PROJECT REVISION "A"

| PROJECT       | : "Villa Collection" - Single Family Dwelling                              | Opt. 1 J.N.: 0699-0638  |
| REVISION      | : Plan 1510: Relocation of shear wall at side of Garage for utility meters |                         |

## PROJECT REVISION "B"

PARTIAL FOUNDATION

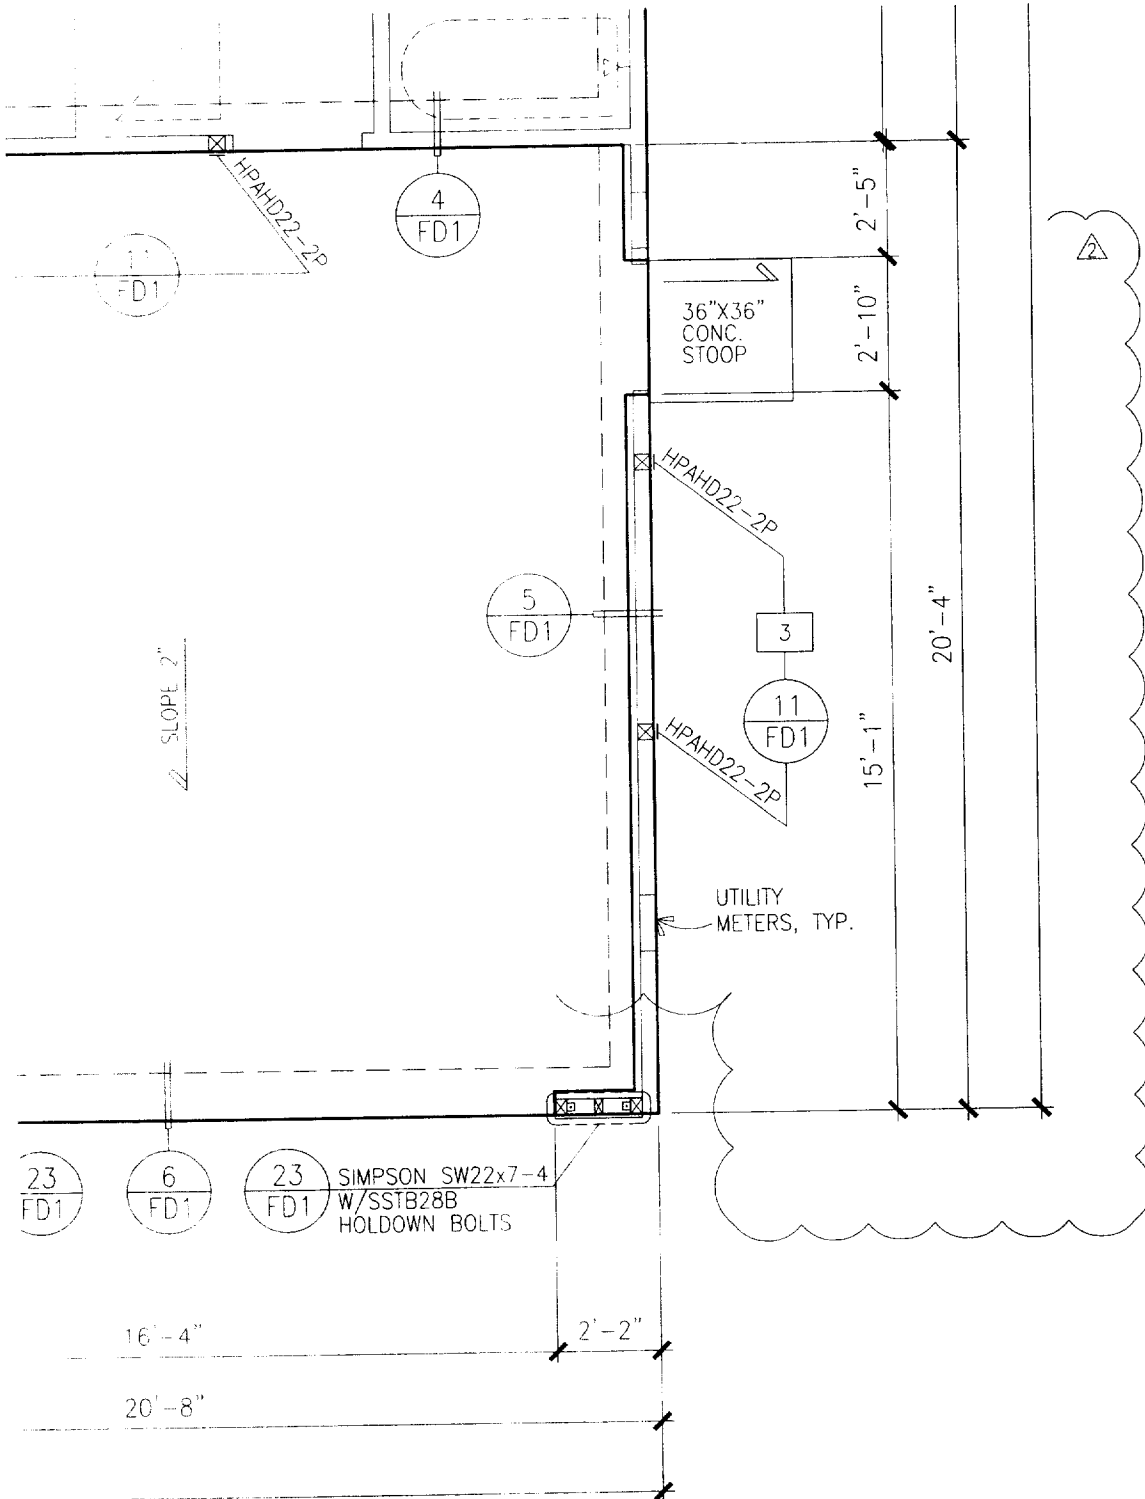
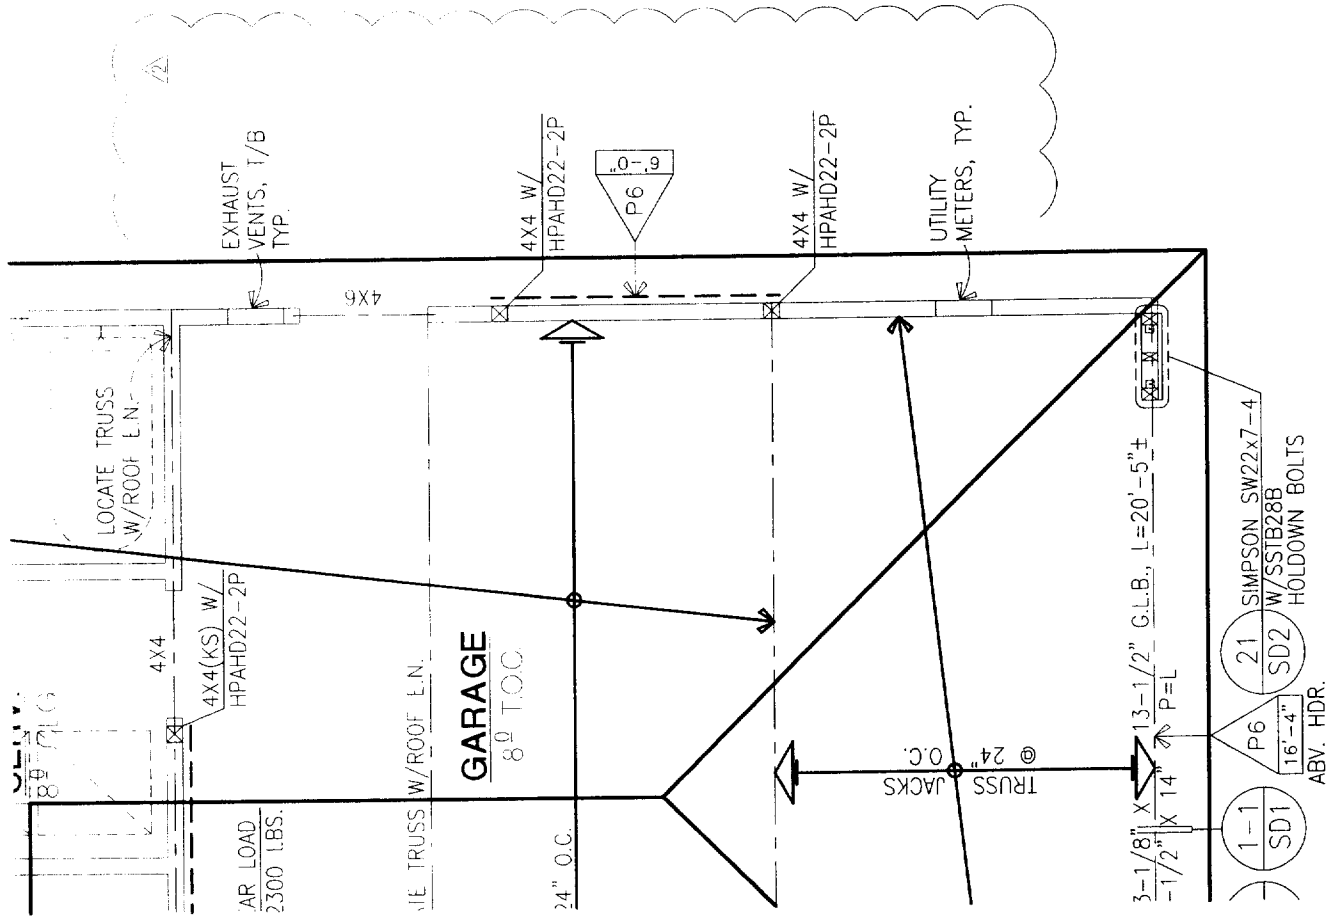
**Relocation of the shear wall at side of Garage for utility meters**

Shear wall type "P6" at side of Garage can be relocated toward Garage firewall to clear the utility meters; i.e., front edge of wall shall be approximately ±8'-0" from front of Garage. Refer to the attached retrofit details "A" and "B" for missed mud-sill anchor bolts and holdowns, respectively.

PARTIAL FOUNDATION

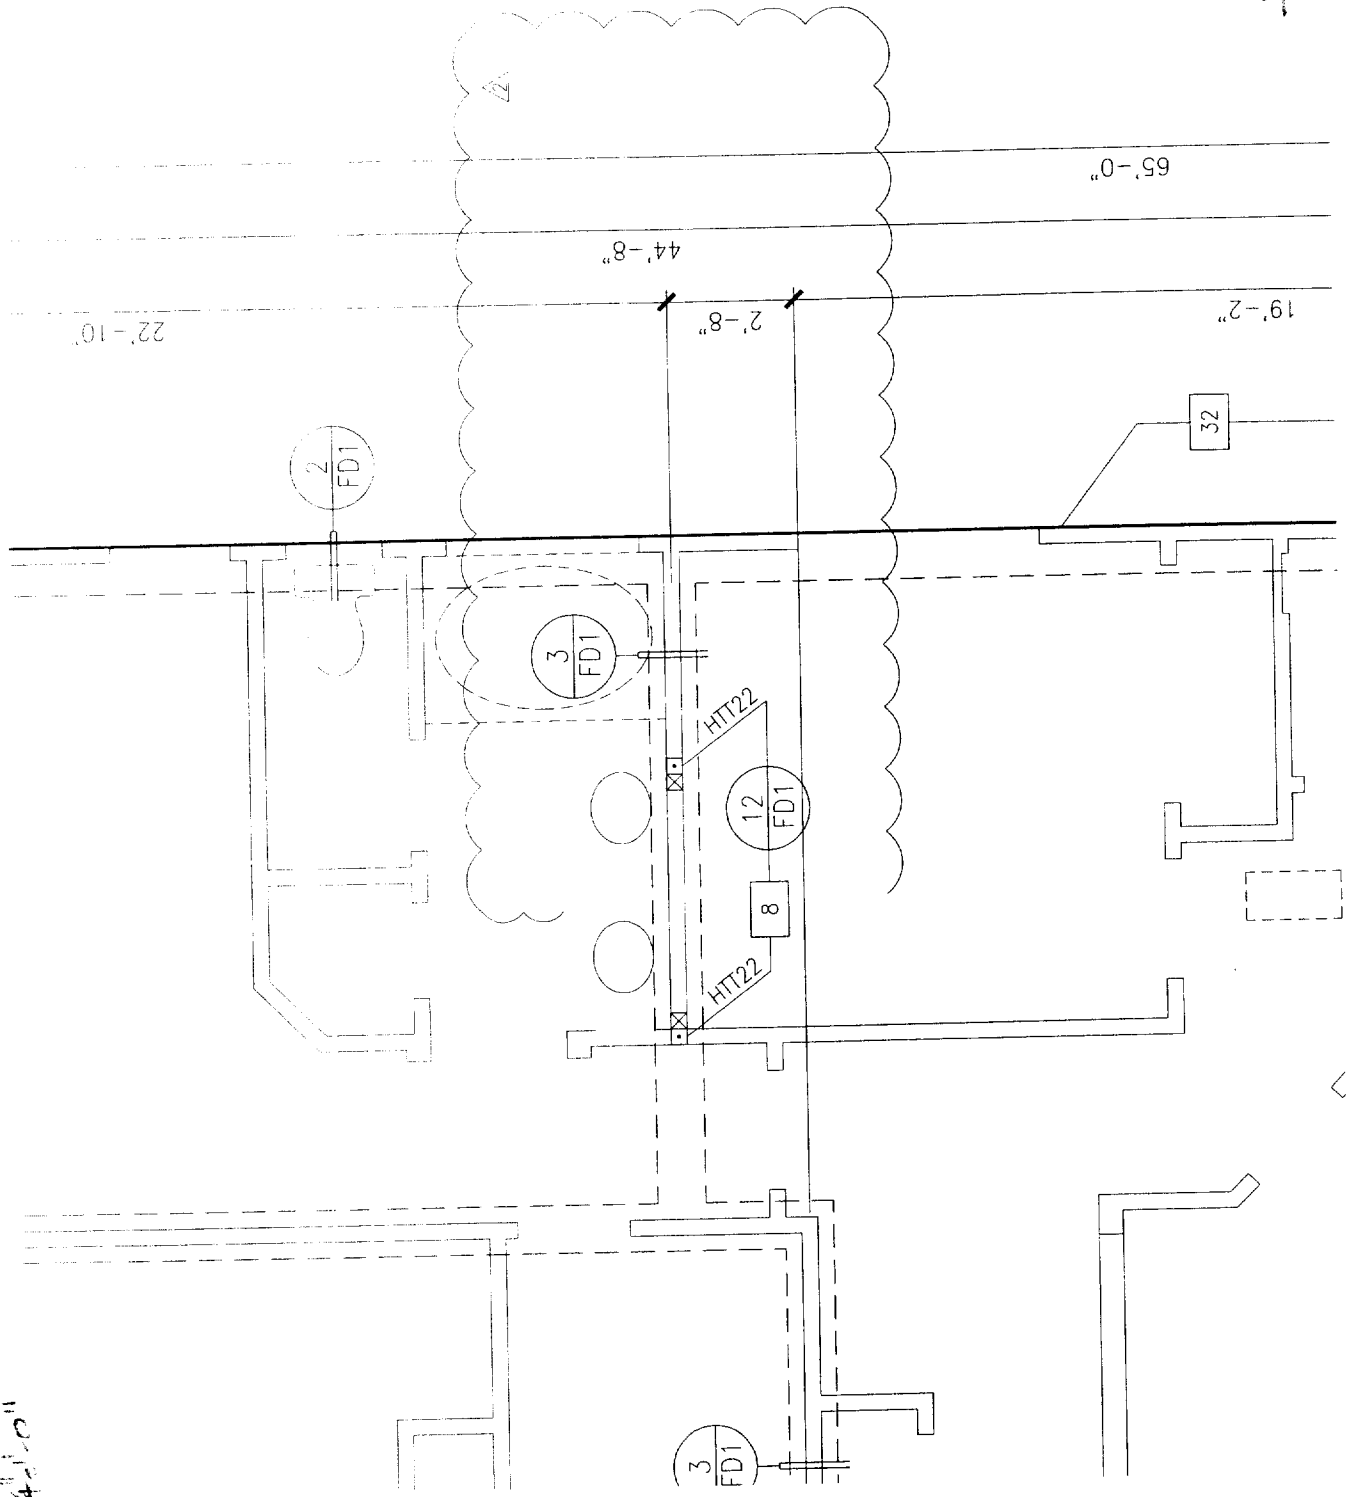
**Shear wall revision at wall between Bedroom #2 and Master Bath**

Where plumbing lines have adversely affected the strength of the mud-sill plate at the shear wall, we have reduced the length of shear wall to clear the area that plate has been penetrated. Therefore, provide shear wall type "P2", L=5'-4", with anchor bolts at 8" o.c. and Simpson HTT22 holdowns at each end. Refer to retrofit details "A" and "B" for missed mud-sill anchor bolts and holdowns, respectively.

**5 ). 1 st FLR. -INT. REAR OF BEDROOM 2:**  $L (ft) = 5.33$

LOAD = ( 121 )x( 44/2 ) +  
 (WIND GOVERNS) ( )x( ) +  
 ( )x( ) +  
 ( )x( ) = 2662 lb  
 SHEAR = ( 2662 )/( 5.33 ) = 499 plf

USE **P2** with 16d Nails at NA in o.c. or 1/2-in Dia. A.B.'s at **16 " o.c.**

O.T.M. = ( 5.33 )x( 8.00 )x( 499 ) = 21296 ft.lb  
 R.M. = ( 18\*(4/2)+10\*8)\*5.33^2/2 = 1648 ft.lb  
 Pt. load = 0 lb, Dist. to closest SW edge, J = 0 ft  
 Superimposed uplift force from shear panel(s) above ----> 0 lb  
 Uplift correction for reduced moment arm in ft, L(hd) ----> 4.83 Uplift x L(sw)/L(hd) = 4182 lb  
 Uplift = (O.T.M. - (2/3xRM) - (2/3xPxJ)) / L = 3789 lb ----> **HTT22**
